Subject: Section 8.6 Shop Fabrication and Field Erection, para. 8.6.4

Edition: ASME STS-1-2006

ASME File: RC #07-1425

Figure 1

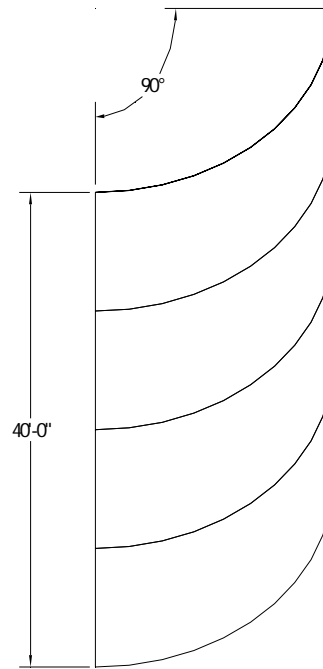
A company fabricates panels for stacks in 90 deg. x 40 ft long sections, which do not have vertical shop weld seams within the 90 deg. arc section. These 40 ft long sections are made from multiple smaller pieces (typically 4 x 10 ft long) based upon material availability. See **Figure 1**. Once panels are delivered to the field for final assembly, four 90 deg x 40 ft sections are welded together to form one 40 ft cylindrical “can” section. Each “can” section will then be circumferentially welded to additional can sections to form the overall stack. The cylindrical can sections that are joined by circumferential welds in the field will have their vertical seams staggered from each other by a minimum of 20 deg.

Does para. 8.6.4 prohibits this type of stack construction?

Response: No
